**ANALYSIS OF A MELCOR INPUT DECK FOR THE
PEACH BOTTOM ATOMIC POWER STATION**

February 2003

Prepared by
OAK RIDGE NATIONAL LABORATORY
P.O. Box 2008
Oak Ridge, Tennessee 37831-8057
managed by
UT-Battelle, LLC
for the
U.S. DEPARTMENT OF ENERGY
under contract DE-AC05-00OR22725

At the request of the Sandia National Laboratories (SNL), a review has been completed of a MELCOR input deck for the Peach Bottom Atomic Power Station that models a majority (if not all) of the emergency core cooling systems. Also modeled is the containment spray function of the residual heat removal systems as well as the leakage path amongst the various reactor-building floors. Included in the deck is a vast array of control functions that mimic the automatic and some of the manual operations that are performed after a reactor trip signal occurs. Intrinsic to these control functions is the ability to operate valves and pumps automatically at the required set points without the user having to stop and restart the code to change either a valve position or to start a pump. This provides a great advantage to the user in performing “what if” calculations. The user need only worry about establishing the initial c

Figure 1. Detail of the temperature profile of the innermost radial ring for the bottommost axial level.

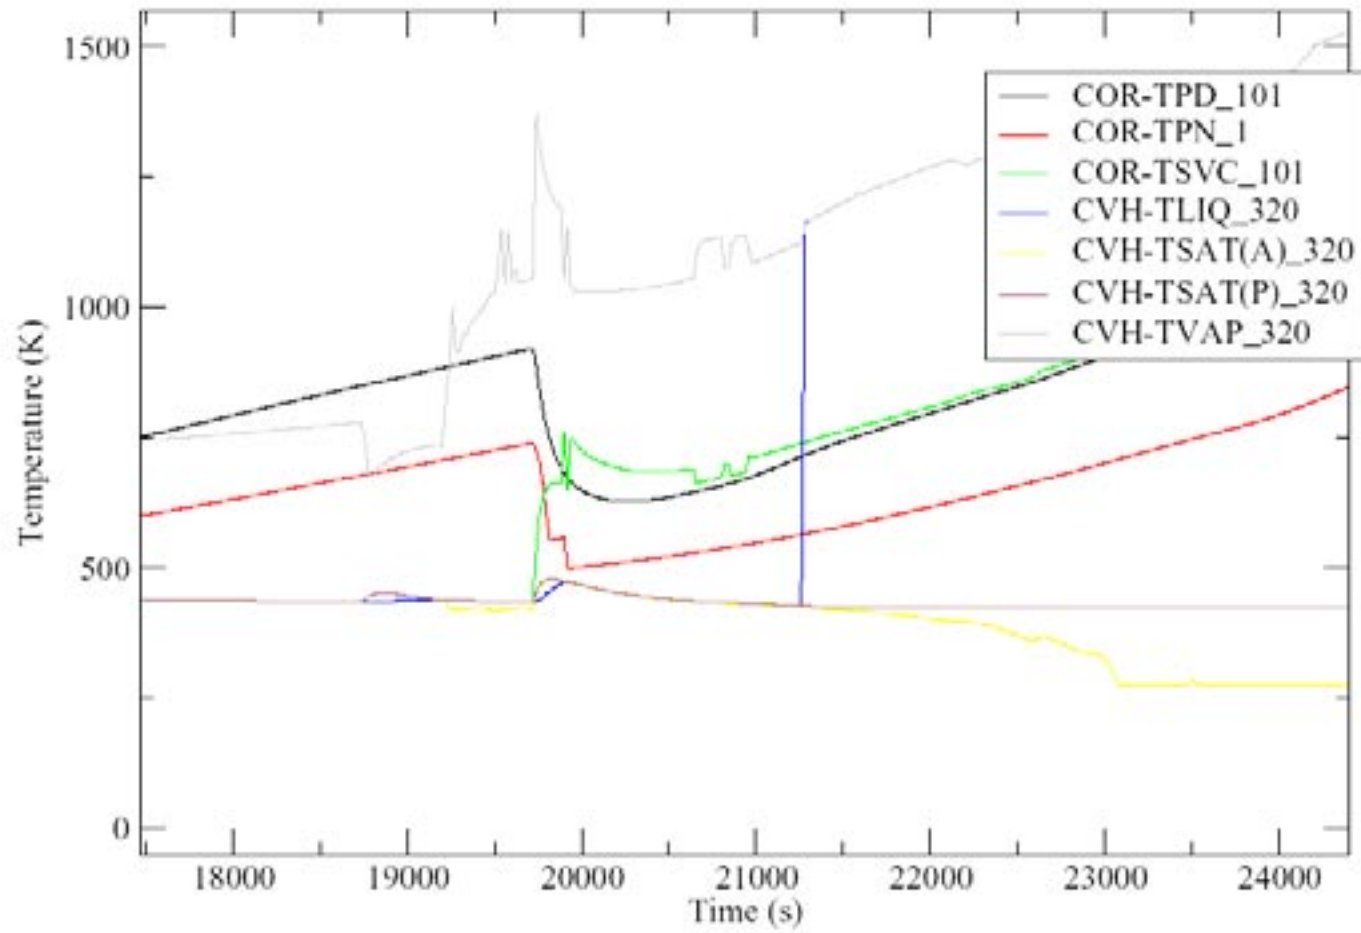
In addition to the above information, it is important to determine the point at which lower-plenum dryout occurs. From Figure 1, dryout occurs slightly after 21,000 s. In NUREG-5942, dryout was reported to occur at approximately 13,000 s. The difference between these values is most likely the result of the initial conditions, an improved core-plate model, and/or smaller radial rings. In NUREG/CR-5942, initial core-plate failure was predicted at slightly before 10,000 s, as opposed to the value given above of nearly 12,000 s. Therefore, core-plate-failure time is not that significantly different. Thus, the largest effect is most likely the reduction in relocating mass as a result of the smaller radial rings.

Figure 2. Temperature profile of lower-head penetrations and two innermost lower head nodes.

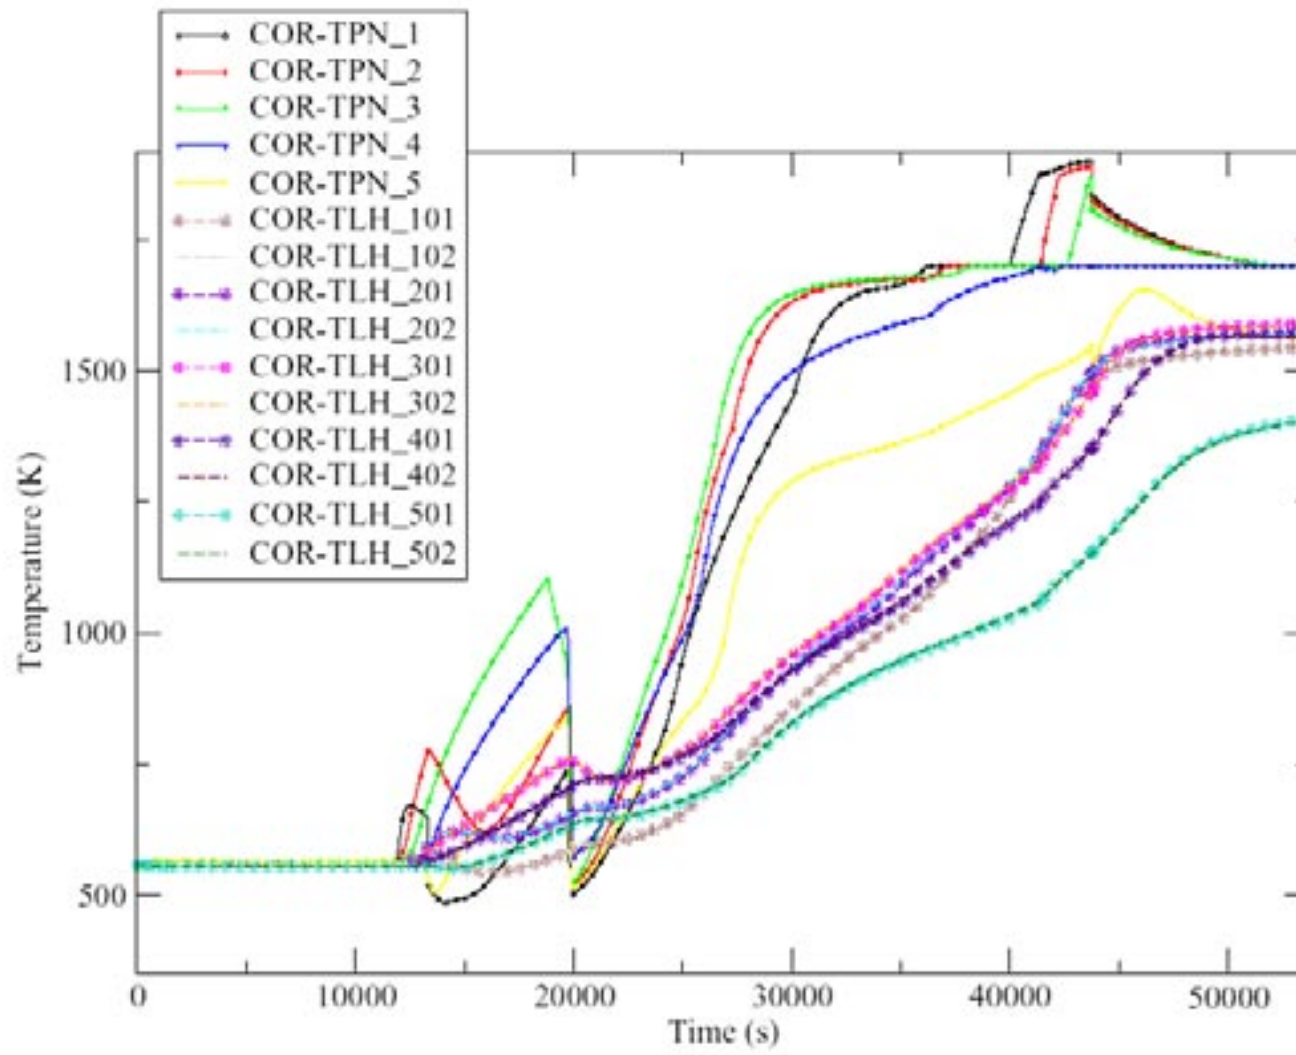
Figure 2 shows the temperature profile of the penetrations and the innermost regions of the lower head. As can be seen from the figure, the penetrations heat up gradually after core-plate failure until around 20,000 s when a sharp drop in temperature occurs. Figure 3 provides a greater detail of this drop for the innermost radial ring. The apparent cause of this temperature drop will be discussed later.

Figure 3. Comparison of penetration temperature in the inner radial ring as the water level drops.

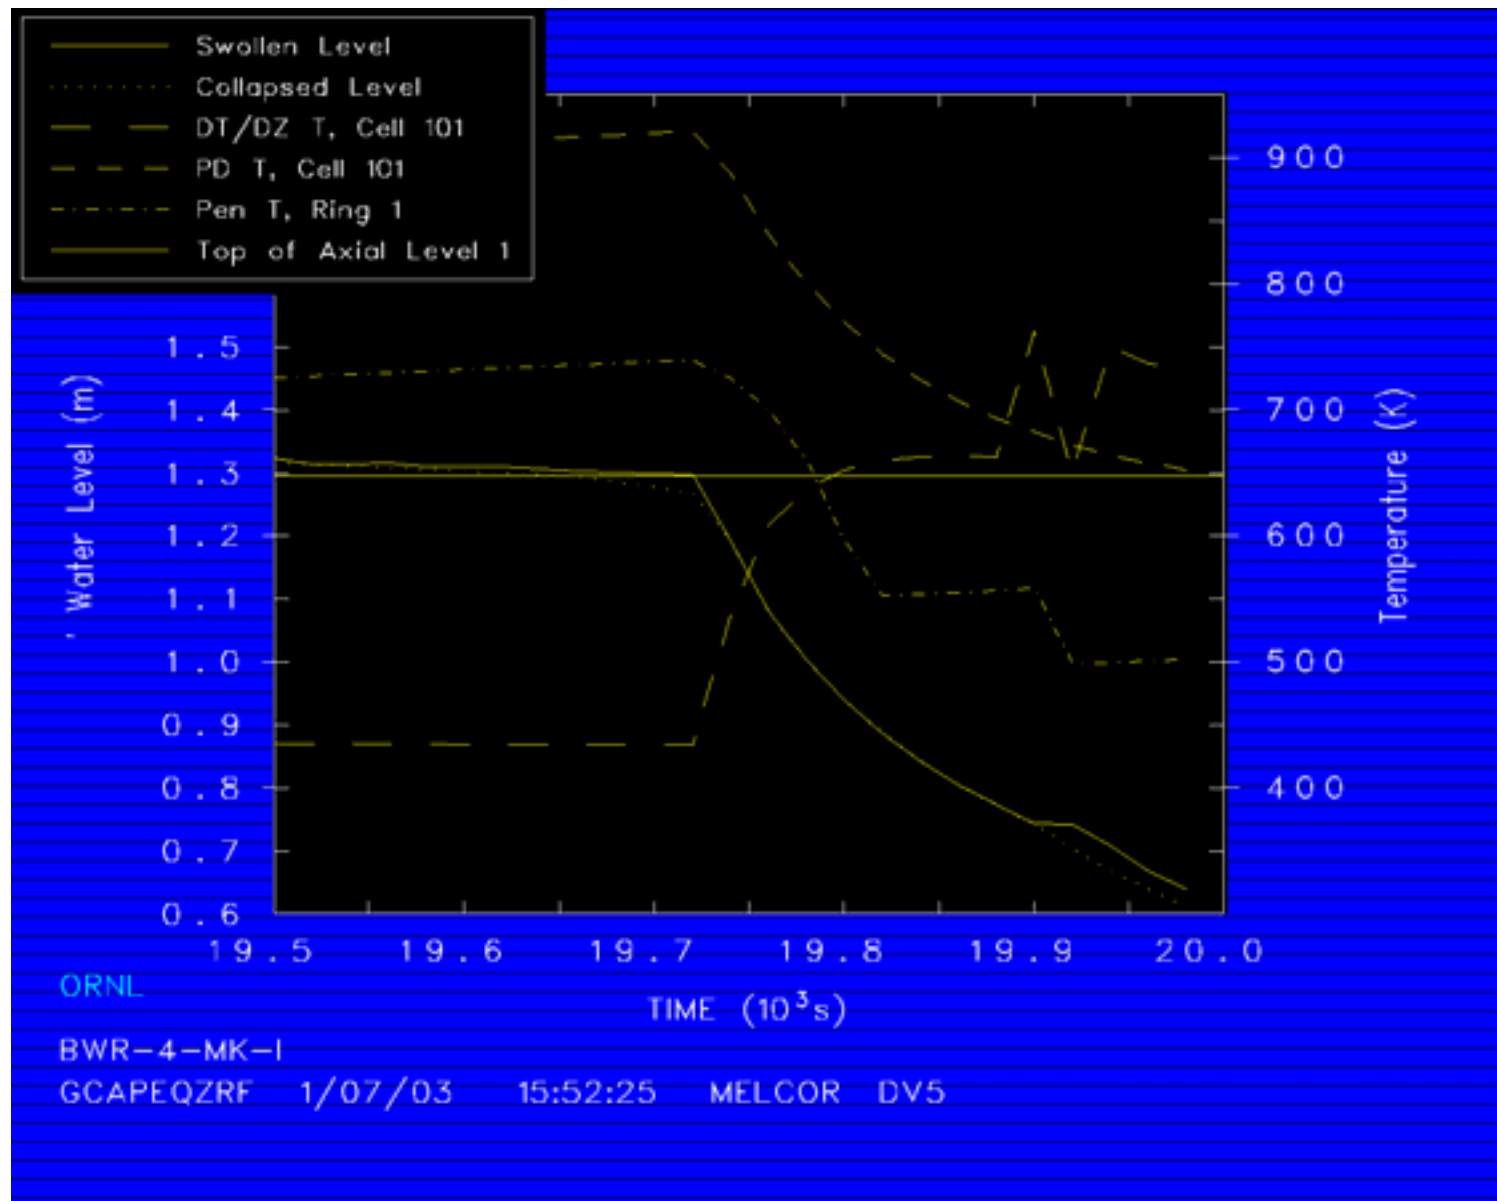
Thus, it is apparent that mass ejection from the vessel is dependent on the failure mechanism of the penetrations alone. Because of this dependence, a thorough examination of the heat-up of the penetrations was performed. During this examination, a discontinuity in the temperature profile of the penetrations was discovered, as noted above and shown in Figure 3. The problem appeared to occur during lower-plenum dryout. When the swollen water level drops to the top of the first axial level, as seen in Figure 3, the temperature of the penetrations drops nearly 500 degrees. This inconsistency is

probably related to a change in the models associated with the regime change, i.e., in going from water covered to a mixture of both air and water.

Figure 4. Mass ejection from the lower plenum to the drywell.

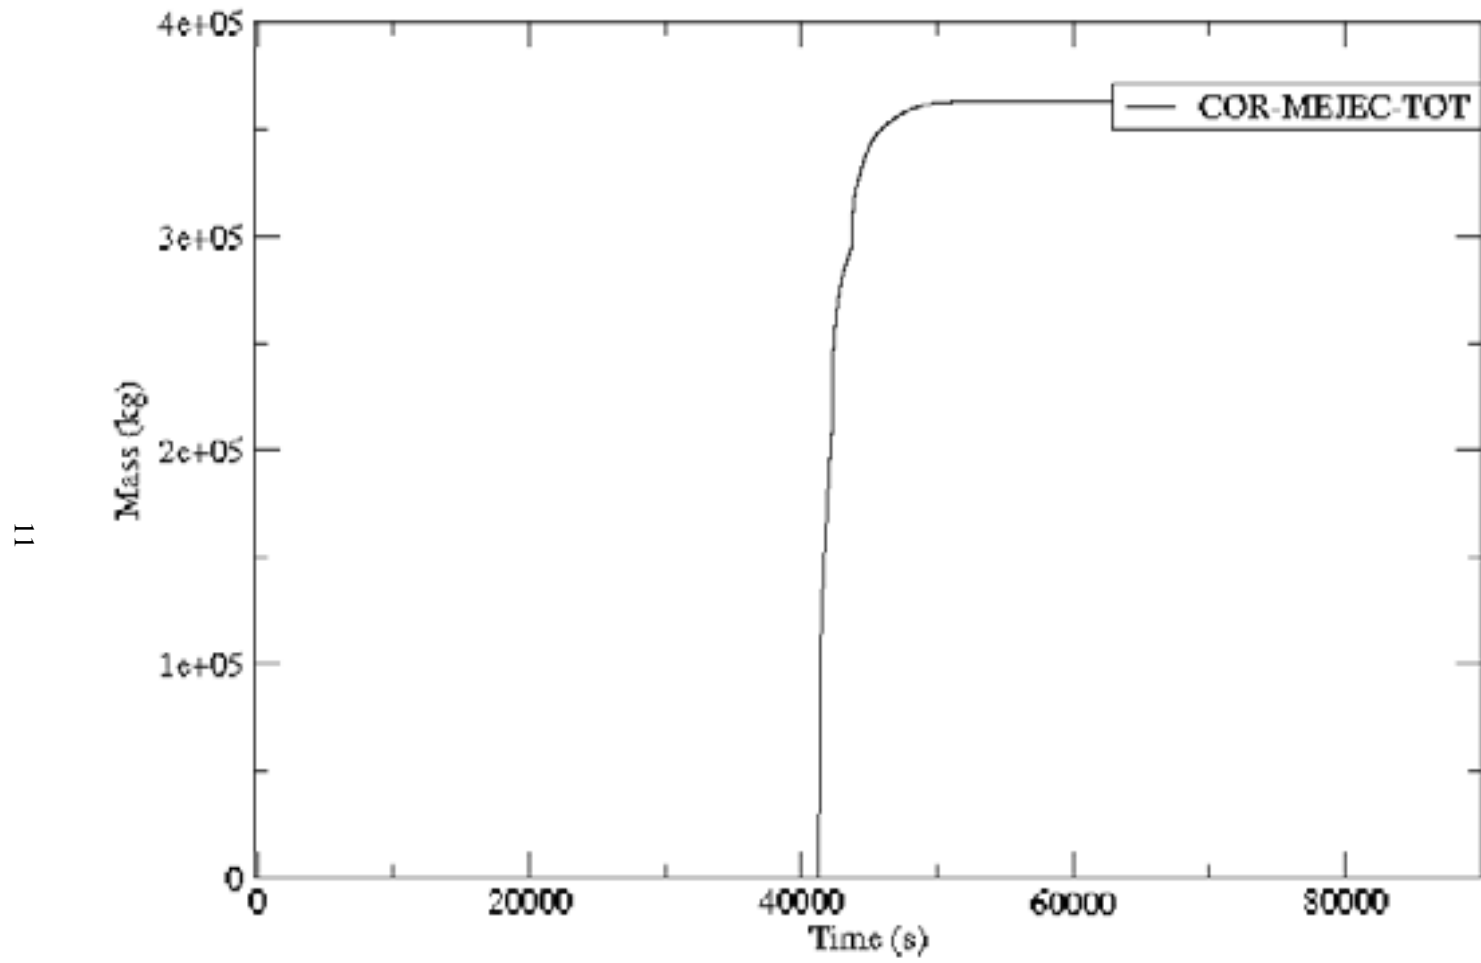
Because of this temperature drop, melt ejection is delayed until after 41,000 s, as seen in Figure 4. Again from NUREG/CR-5942, melt ejection was previously determined to occur at slightly after 16,000 s. Examining Figure 5, which shows the debris-bed temperatures starting at 25,000 s, the debris-bed temperatures are in excess of the temperature required to fail the interstitial stainless-steel guide tubes. Therefore, melt ejection should have occurred significantly earlier than predicted; this is the first inconsistency.

Because of the late melt ejection, a large portion of the debris is liquid or extremely hot. This leads to the second questionable result: the speed that material is ejected through the penetration. Starting at 41,303 s (the first penetration failure) to 42,234 s (second penetration failure), material is ejected at a very large rate, nearly 210,000 kg of material is ejected (over half of the total ejected mass) or an average rate of 226 kg/s. As stated, this is a direct result of the delay in failure of the penetrations and the buildup of molten material within the debris bed. Because of this large melt ejection, the vessel itself never fails, and all material exits through the penetrations.
